PLANNING & ENVIRONMENT ACT 1987
WHITTLESEA PLANNING SCHEME
 Planning Permit No: 716630 (Amendment)
ENDORSED PLAN
 Endorsed to show compliance with Condition (s) 3
 (Functional Layout Plan - Stage 9)
 Sheet 1 of 2 Date: 07/05/2021

FUNCTIONAL LAYOUT PLAN

RATHDOWNE ESTATE STAGE 9
 FUNCTIONAL LAYOUT PLAN

PLANNING & ENVIRONMENT ACT 1987
WHITTLESEA PLANNING SCHEME
 Planning Permit No: 716630 (Amendment)
ENDORSED PLAN
 Endorsed to show compliance with Condition (s) 3
 (Functional Layout Plan - Stage 9)
 Sheet 2 of 2 Date: 07/05/2021

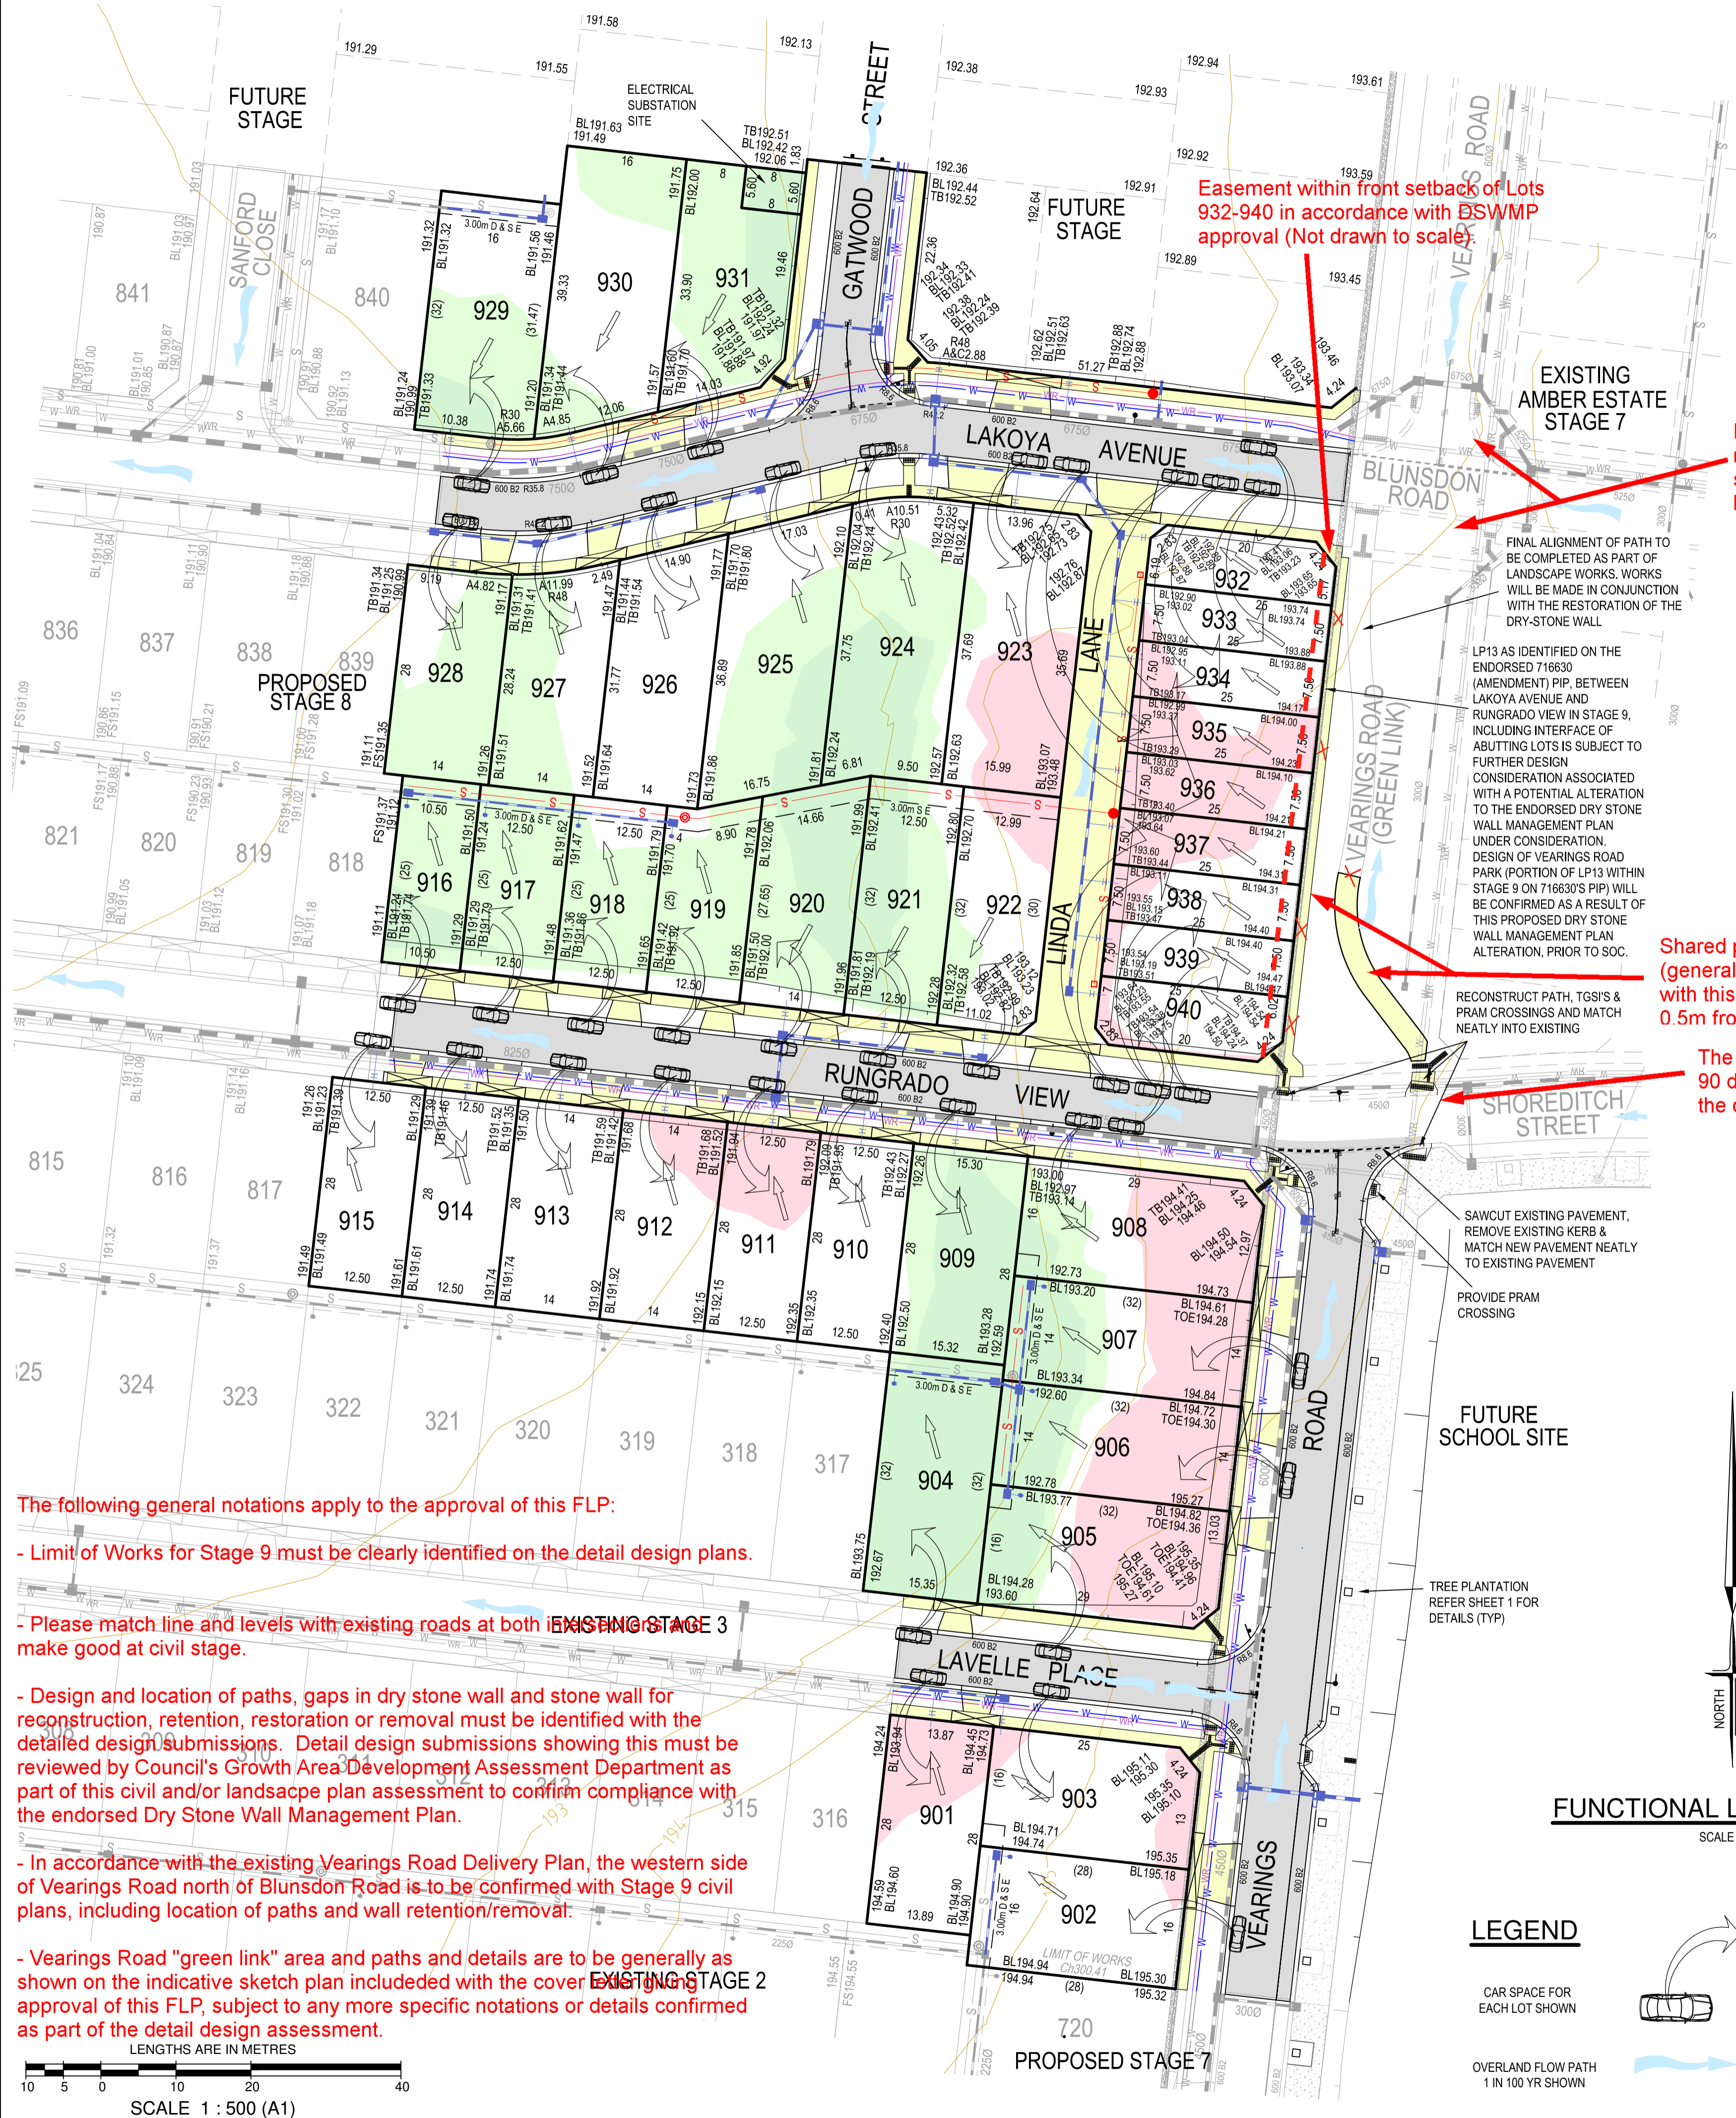
Footpath over Veerings Road at Blunson Road must be realigned (generally as per the indicative sketch in the cover letter with this FLP approval), to be shown with detail design plans.

Shared path to be relocated to service Lots 932-940 (generally as per the indicative sketch in the cover letter with this FLP approval), and to be offset approximately 0.5m from the retained dry stone wall.

The Shared path crossing of Shoreditch Street must be constructed to cross at 90 degrees to the road centreline. The 90 degree crossing must be shown on the detail design plans.

- Limit of Works for Stage 9 must be clearly identified on the detail design plans.
- Please match line and levels with existing roads at both EXISTING STAGE 3 make good at civil stage.

- Design and location of paths, gaps in dry stone wall and stone wall for reconstruction, retention, restoration or removal must be identified with the detailed design submissions. Detail design submissions showing this must be reviewed by Council's Growth Area Development Assessment Department as part of this civil and/or landscape plan assessment to confirm compliance with the endorsed Dry Stone Wall Management Plan.

- In accordance with the existing Veerings Road Delivery Plan, the western side of Veerings Road north of Blunson Road is to be confirmed with Stage 9 civil plans, including location of paths and wall retention/removal.

- Veerings Road "green link" area and paths and details are to be generally as shown on the indicative sketch plan included with the cover letter with this FLP, subject to any more specific notations or details confirmed as part of the detail design assessment.

20.60m ROAD
VEARINGS ROAD
 LOCAL ACCESS STREET - LEVEL 1

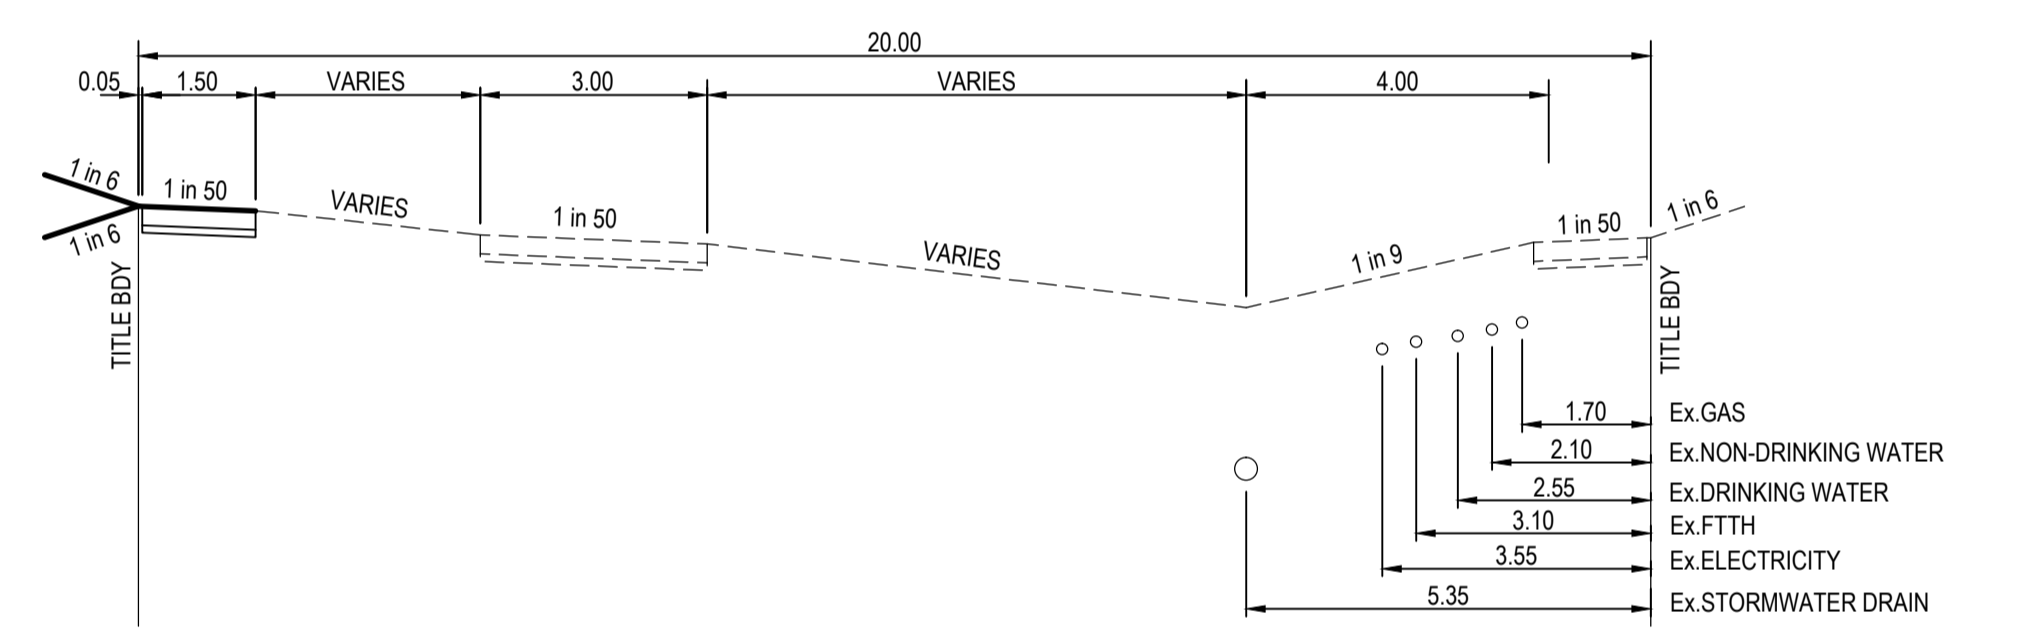
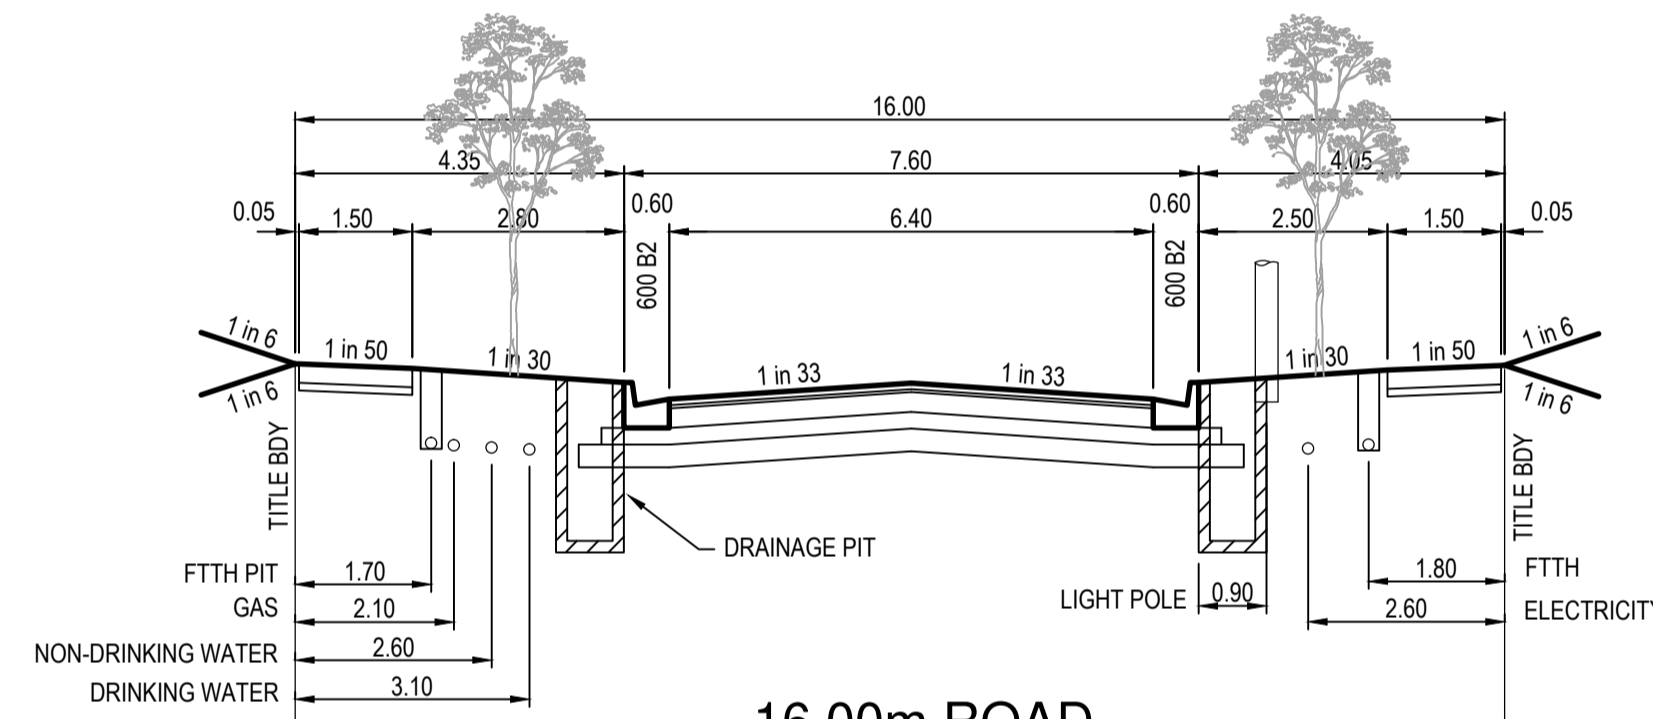
See also notations on Sheet 1.
 Notations may especially impact cross section detail shown for Vearings Road and require changes as part of detail design.
